SITE SUPPLEMENTAL INSTRUCTION

PROJECT: Forestside Estates
Attmar & Palleschi Drive
Brampton, Ontario

SITE SI NO. E-6

PURPOSE: Revised as per Arch SI A01 and Mech S SI M-2.

TITLE **ROOF PLAN ELECTRICAL**

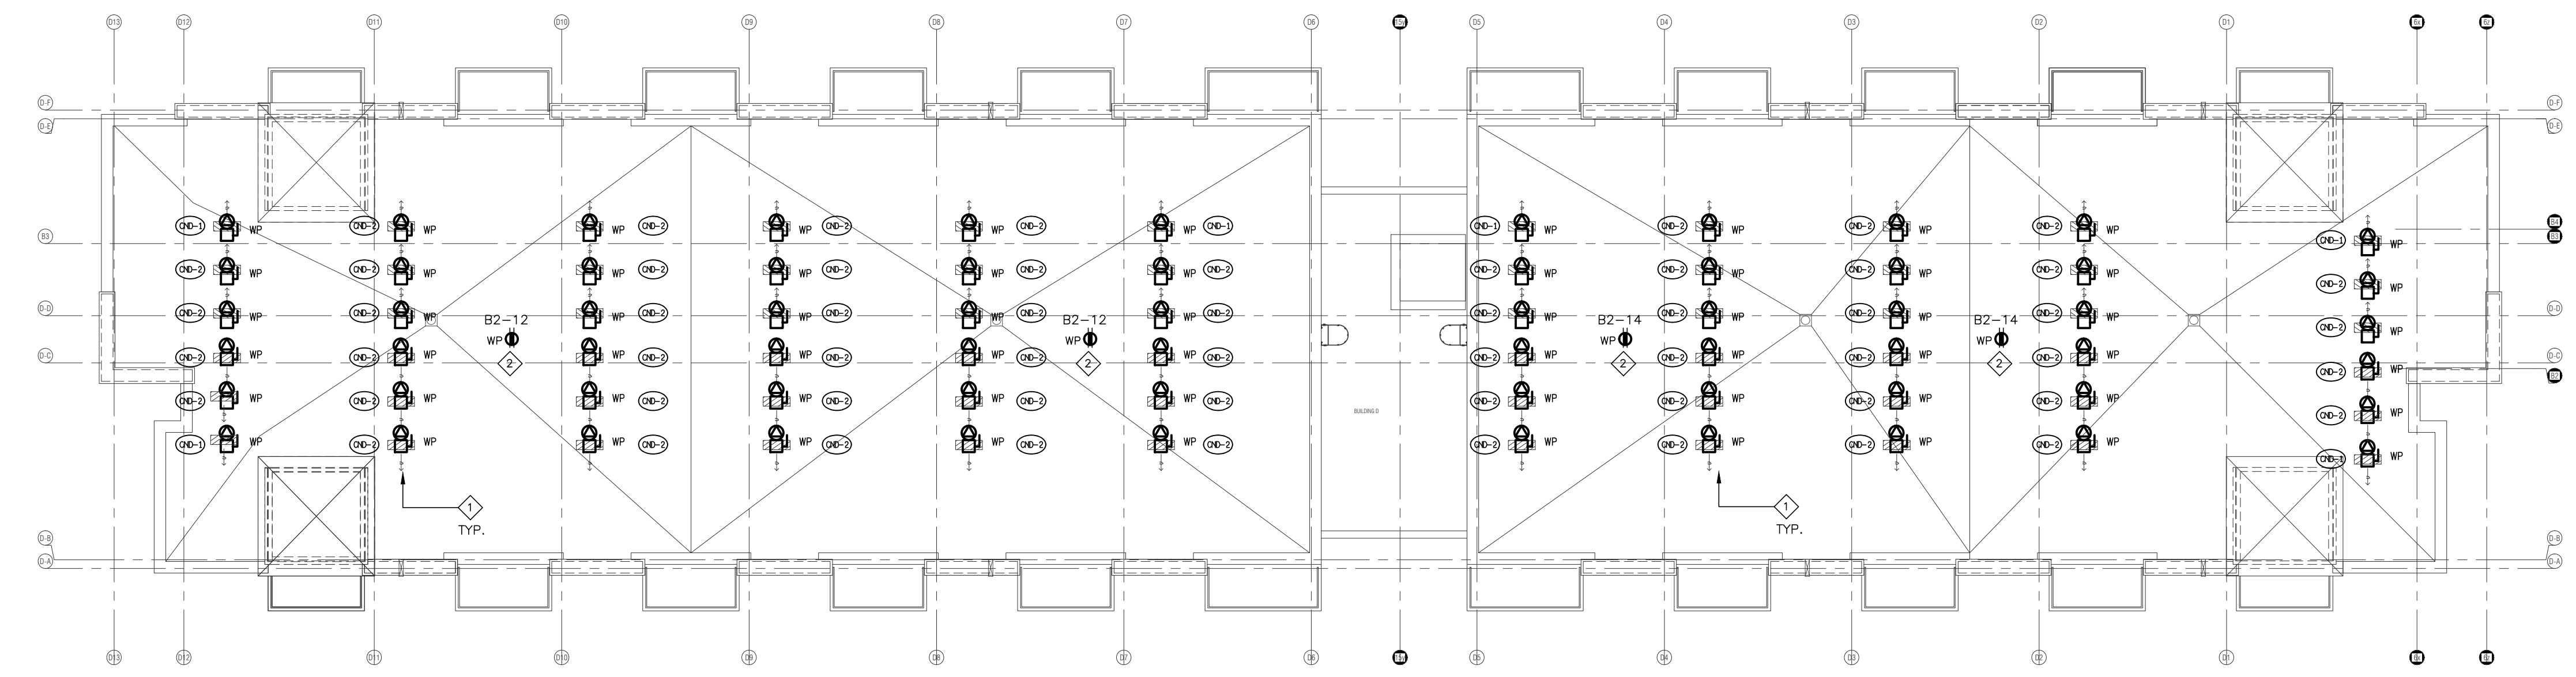
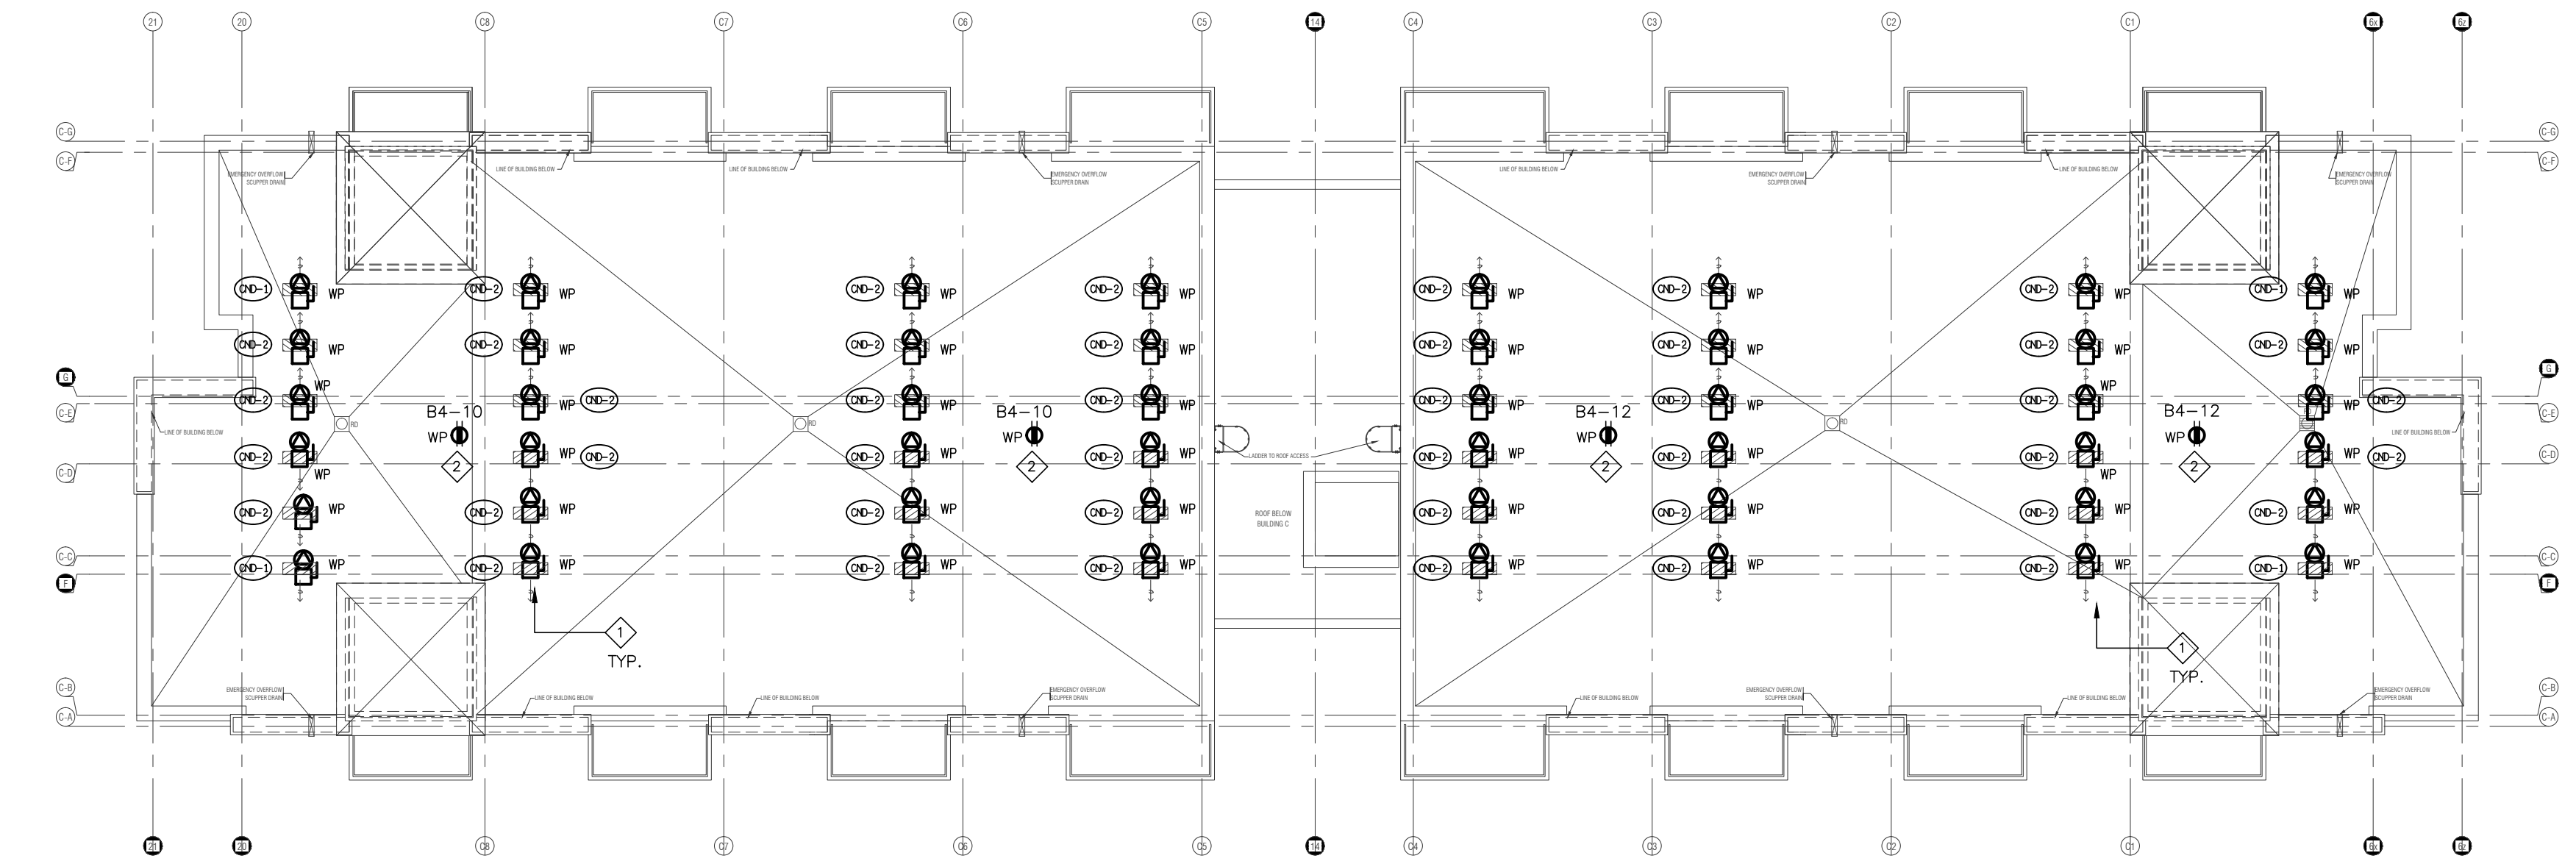
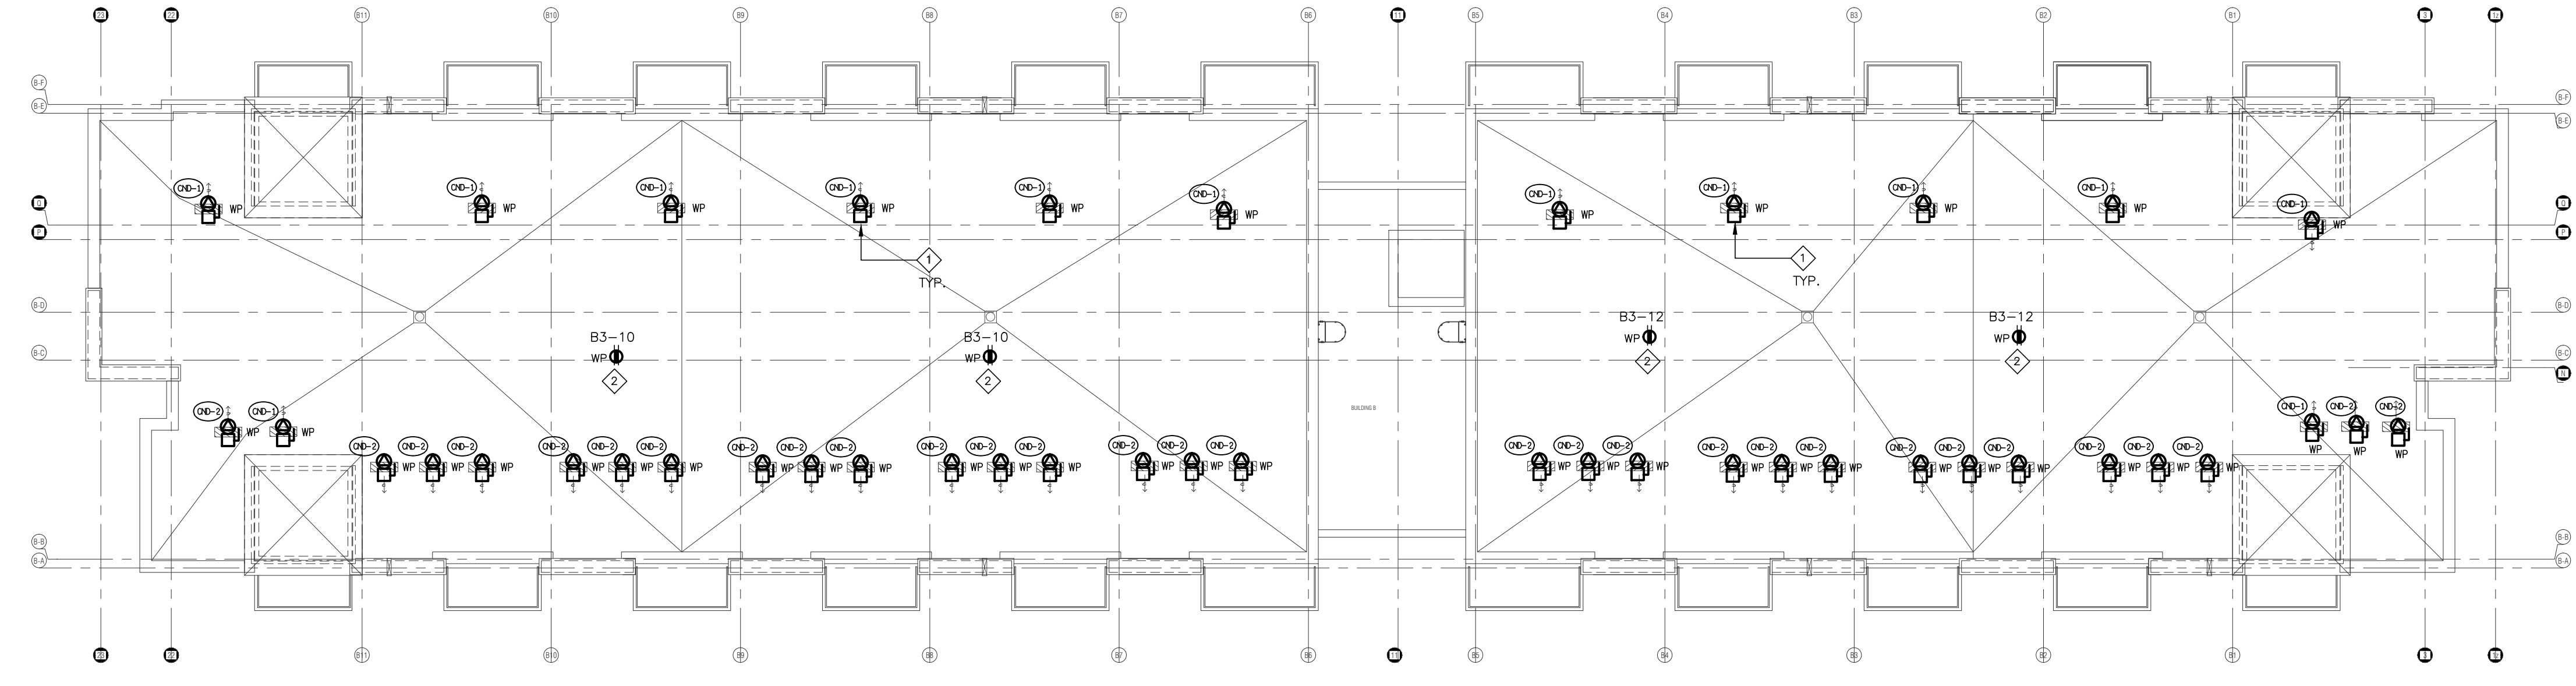
3.0 Reference Drawings E-7 (Roof -Electrical) Issued

3.1 Add: Condensing units for building D as shown.
